SUBJECT: Part 21 rept re Foxboro Spec 200 termination modules, four Model N2AK+T & three Model N2AK+K. Defects identified in metallic termination module labels found w/clearances less than acceptable Foxboro std of 0.06 inches.

Subject: 10 CFR 21 Notification
R. E. Ginna Nuclear Power Plant
Docket No. 50-244

SUBJECT: Termination Modules used in Foxboro's SPEC 200
Product Line
Various Part Numbers (See Attachment I)

TERMINATION MODULE LABEL PLACEMENT

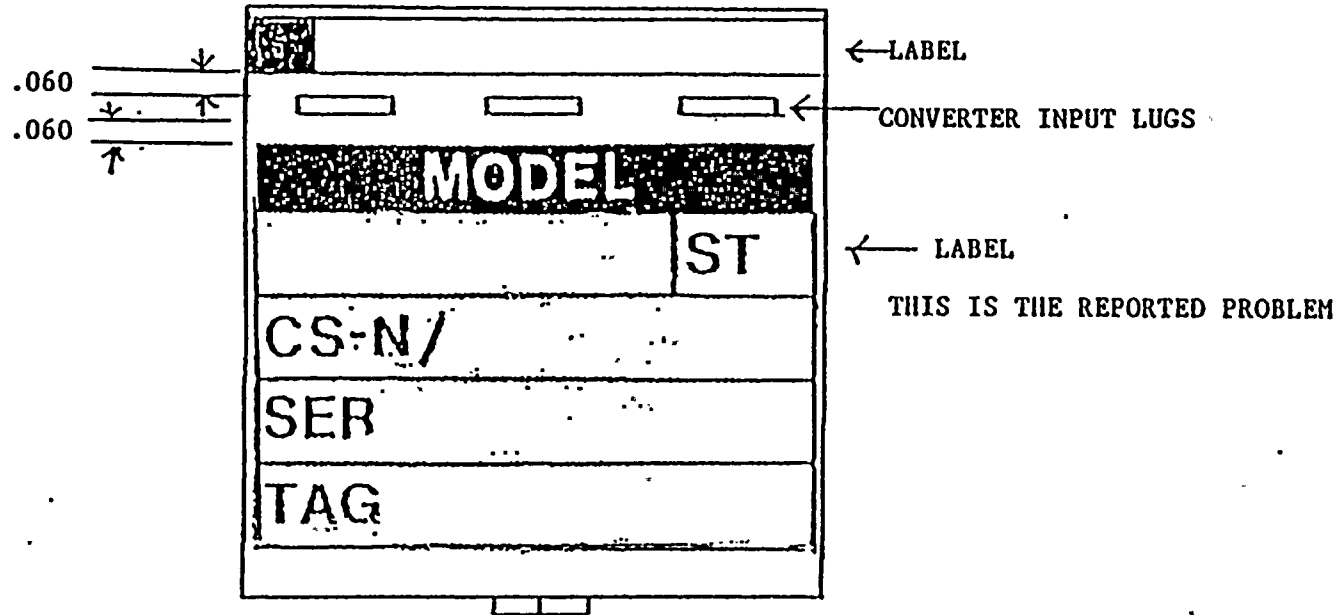
Also attached is the technical description of one of the modules (SI 1-01693), Attachment II. We have highlighted the area of potential problem on this attachment.

This is the first reported problem since we introduced these modules more than 18 years ago. We believe if similar modules are already installed in your system and no problems have been experienced to-date, the shorting of the label to the lugs is unlikely. However, we are recommending that you inspect the units for label proximity to the lugs. Any suspected units must be removed and tested for a short circuit between the spade lugs. If a short circuit exists, the only corrective action required is to move the label away from the lugs. Please check your spare parts inventory also.

We have instituted the use of a non-metallic label so as to avoid any future problems.
